**TITLE:** PUBLIC HEARING regarding a review and recommendation for a Minor Subdivision Plat for Campstool Bluffs, Laramie County, located on Lot 3, Riata Ranch North Forty Record of Survey.

Steil Surveying Services, LLC, on behalf of Brian McKnight, has submitted a Minor Plat application for Campstool Bluffs, a replat of Lot 3, Riata Ranch North Forty Record of Survey. The subject property is located at the intersection of Riata Loop and Arena Lane, Cheyenne, WY. The subdivision divides the existing 39.66 acre parcel into six (6) tracts that average 6.17 acres.

**PZ-26-00034**

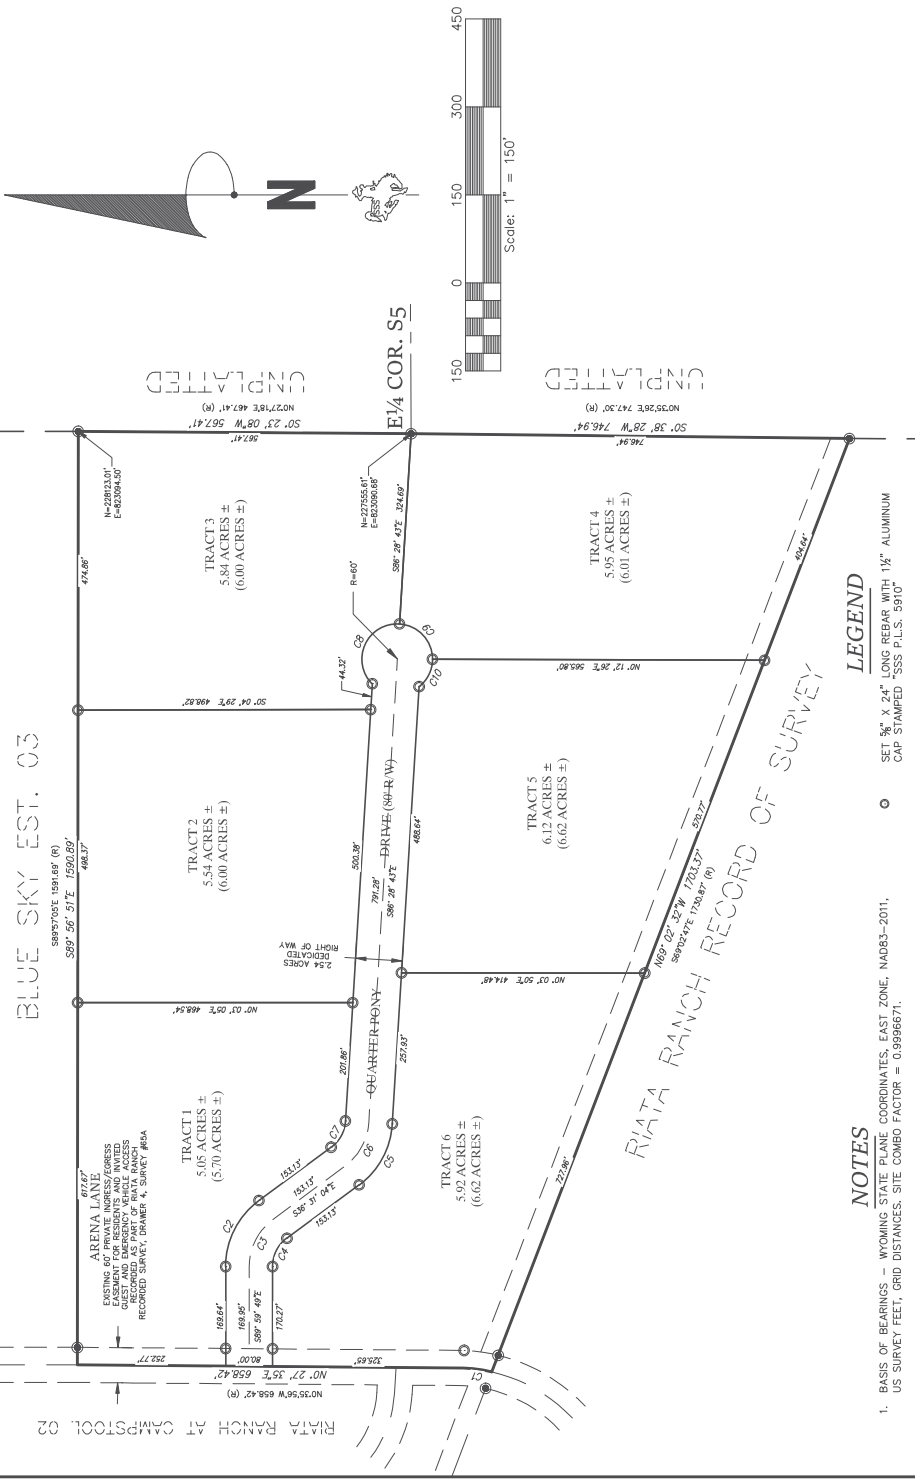
04/21/2026	Workflow	ENGINEERS REVIEW	GENERAL	1st Review - Engineer Comments:	SCOTT.LARSON@ LARAMIECOUNTY WY.GOV
<ol style="list-style-type: none"> <li>1. LABELED</li> <li>2. ADDED</li> <li>3. NOTE REMOVED</li> <li>4. ADDED NOTE</li> <li>5. CORRECTED</li> <li>6. ACK</li> <li>7. ACK</li> </ol>				<ol style="list-style-type: none"> <li>1. There appears to be a utility easement that runs along the southern boundary line of Tracts 4-6 that is not labeled as to what the easement is and what is the width of the easement.</li> <li>2. There is a 10' utility easement that ties into this platted area (at Tract 1) from Blue Sky Estates, 3rd Filing that needs to be shown on this plat.</li> <li>3. Note 5 indicates "All Utilities to be placed in the road right of ways as required by Laramie County". This is not necessarily a requirement of Laramie County 4-5-103.xi. states, "All utility facilities, including but not limited to gas, electrical power, telephone and CATV cables, shall be located underground throughout the subdivision/development. As far as possible, all utilities shall be placed in the public street or road rights-of-way. Easements shall be provided for all public utilities if utilities cannot be placed in public street or road rights-of-way. If an easement is necessary, the developer shall provide written evidence detailing why utilities cannot be placed in the right-of-way".</li> <li>4. The note "There shall be no public maintenance of internal roadways or access easements", is not shown on the plat.</li> <li>5. There appears to be a mistake in comparing the differences of the distances along the east boundary of TRACT 3. The Record distance (R) is shown as 467.41' and the actual distance is shown as 567.41'. Both the Riata Ranch North</li> </ol>

Forty Record of Survey and the legal description of the property indicate that the distance is 567.41'.  
 6.The Preliminary Drainage Report adequately addresses the drainage characteristics for the subdivision at this stage. A Final Drainage Report shall be submitted with the roadway construction plan submittal and will provide additional information and more detailed information for the culverts, roadway drainage, etc.  
 7.The proposed roadway shall be designed and constructed per the regulations and design plans submitted to the County for review and approval.

<p>04/22/2026</p> <p>ACK</p>	<p>Workflow</p>	<p>ENVIRONMENTAL HEALTH REVIEW GENERAL</p>	<p>Wastewater permits are required for each lot. All small wastewater systems must have a 50 setback from all property lines. Provide careful consideration for lots with slope. A DEQ letter and Chapter 23 report must be submitted to Environmental Health along with the signed final plat prior to application for any permits</p>	<p>TIFFANY.GAERTNER@LARAMIECOUNTY.WY.GOV</p>
<p>04/22/2026</p> <p>1. ACK 2. ACK 3. ADDED 4. ADDED</p>	<p>Workflow</p>	<p>PUBLIC WORKS REVIEW GENERAL</p>	<p>1. All comments from the review engineer and surveyor shall be addressed and resolved appropriately.          2. Quarter Pony Drive shall be designed and built to the current road standards within the Laramie County Land Use Regulations. A right-of-way/grading permit through Laramie County Public Works will be required. Please apply through the SmartGov portal. Call (307-633-4302) or email (permits@laramiecountywv.gov) Public Works for more information.          3. A note shall be added to the plat indicating "there will be no public maintenance of internal roadways/access easements."          4. A note shall be added to the plat indicating "All Tracts are to be accessed off internal roadways/access easements."</p>	<p>MOLLY.BENNETT@LARAMIECOUNTY.WY.GOV</p>

- 1. CORRECTED
- 2. REMOVED

04/24/2026	Workflow	COUNTY REAL ESTATE OFFICE REVIEW	GENERAL	Changes look good.	RACHEL.TRUDEAU@LARAMIECOUNTY.WY.GOV
04/27/2026	Workflow	ENGINEERS REVIEW	GENERAL	2nd Review - Previous comments have been adequately addressed on the revised/updated plat drawing. No further comments at this time.	SCOTT.LARSON@LARAMIECOUNTY.WY.GOV
